Access Compliance Report

Public Rights-of-Way

(Curb Ramps)

Intersection ID: 47944	Main Street: SHARON_VIEW_RD	Cross Street: PHILLIPS_GATE_DR	Location: NW
ADA ID: 734D81209089	Ramp Type: BlendTrans2	Initial Pass/Fail: Fail	Overall Compliance: No
		Severity Score: 1.25

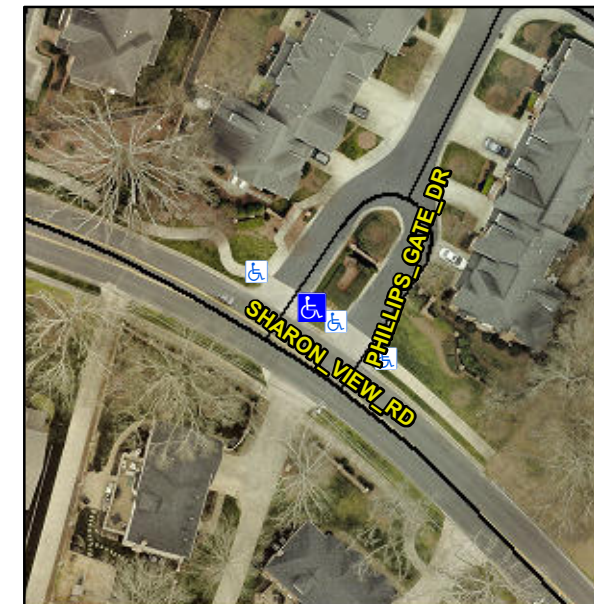
NO CURB LINE

R304.5.3

Compliance	Description	Data	Compliance	Description	Data
N/A	Ramp Length (in)	87.0	Yes	BlendTrans Slope (%)	0.6
Yes	Ramp Width (in)	60.0	No	BlendTrans XSlope (%)	2.7
N/A	Flare Type LT	N/A	N/A	Flare Type RT	N/A
N/A	Flare Slope LT (%)	N/A	N/A	Flare Slope RT (%)	N/A
N/A	Flare Traversable LT?	N/A	N/A	Flare Traversable RT?	N/A
N/A	Landing Length (in)	N/A	N/A	DWS Provided?	N/A
N/A	Landing Width (in)	N/A	N/A	DWS Contrast?	N/A
N/A	Landing Slope (%)	N/A	N/A	DWS Length (in)	N/A
N/A	Landing X Slope (%)	N/A	N/A	DWS Full Width?	N/A
N/A	Landing Curb? (Y/N)	N/A	N/A	DWS Offset (in)	N/A
N/A	Shared Landing?	N/A			
N/A	Gutter Ponding?	N/A	N/A	Gutter Slope (%)	N/A
N/A	Gutter Lip Ht (in)	N/A	N/A	Gutter X Slope (%)	N/A
N/A	Painted X Walk1?	No	N/A	Painted X Walk2?	N/A
	X Walk 1 Direction	To NW		X Walk 2 Direction	N/A
	X Walk 1 Width (in)	N/A		X Walk 2 Width (in)	N/A
	X Walk 1 Slope (%)	0.9		X Walk 2 Slope (%)	N/A
	X Walk 1 X Slope (%)	1.8		X Walk 2 X Slope (%)	N/A

Remove & Replace Curb Ramp With Two New Directional Ramps or Equivalent.
